**ADDENDUM NO. 3****BID NO. 23-05  
SEWER REHABILITATION  
(GILES LANE & ROUTE 40 AREAS)**

**23-05**  
**GILES LN AREA**  
**SEWER MAIN LINING**  
**AND MANHOLE REHAB**

**CAP#: UTL-22-15**

**PAGE 01**

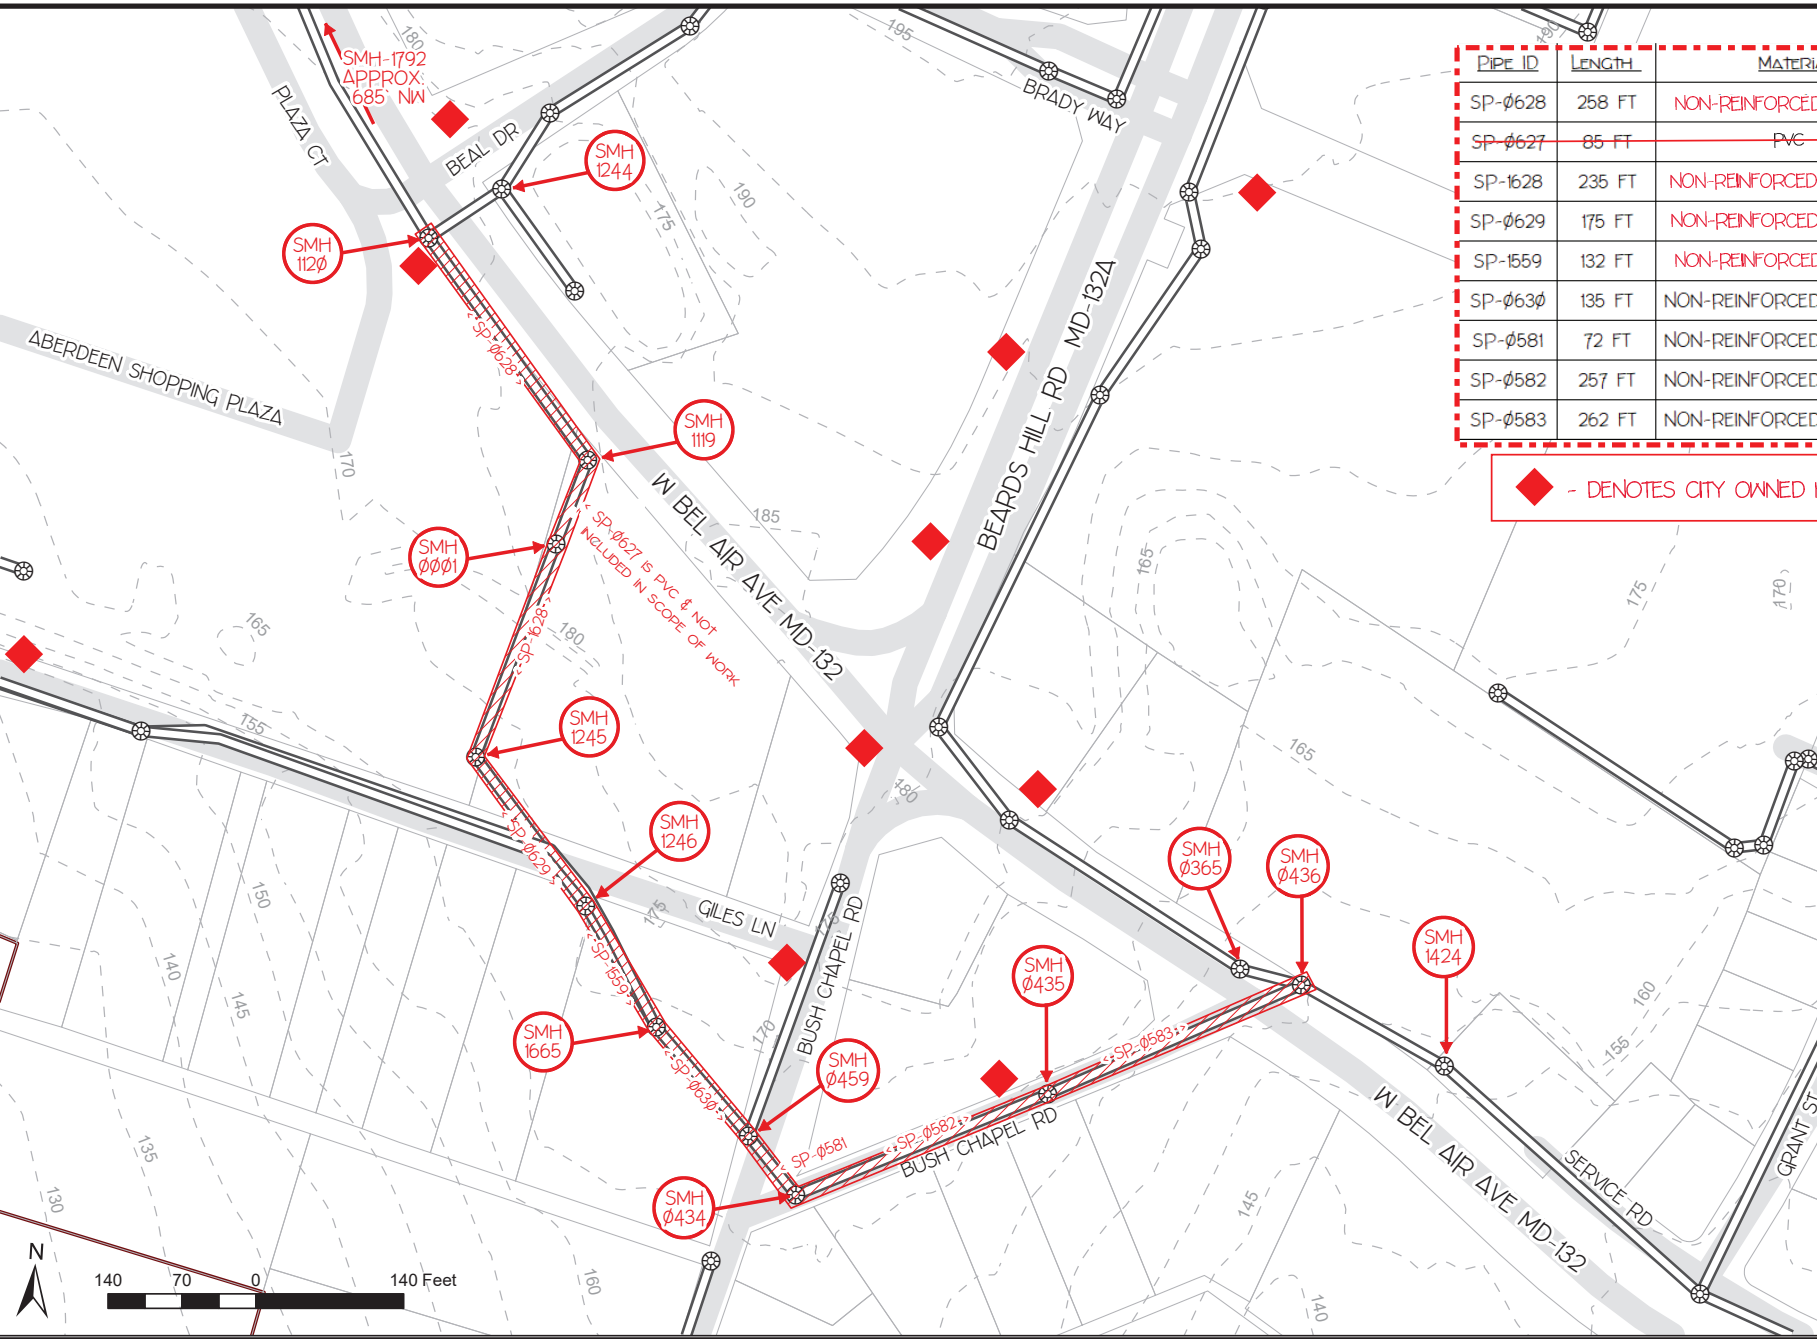
Q1: What are the pipe materials, clay or concrete?

Q2: Are there any features on the project drawings that should not be included in the scope of work?

Q5: Will hydrants be available in the area, or will the contractor need to bring in water?

**A1: The material for each pipe segment within the scope of the project has been corrected to Non-Reinforced Concrete. Bidders should also note that this type of Non-Reinforced Concrete pipe is a Heavy-Walled 10" pipe and it may have any inner diameter that differs from what is typically expected from 10" concrete pipe. The successful bidder will be required to verify inner diameters before ordering liner materials. (corrected documents are attached to this addendum)**

**A2: Pipe segment SP-0627 is PVC at approximately 85 linear feet and should not be included in the scope of work. Also, SMH-1090 has been verified to be on a separate gravity line not in the scope of this project. (corrected documents are attached to this addendum)**

**A5: The City will make hydrants in the area available for lining operations. Hydrant locations have been added to the project drawings. (corrected documents are attached to this addendum)**
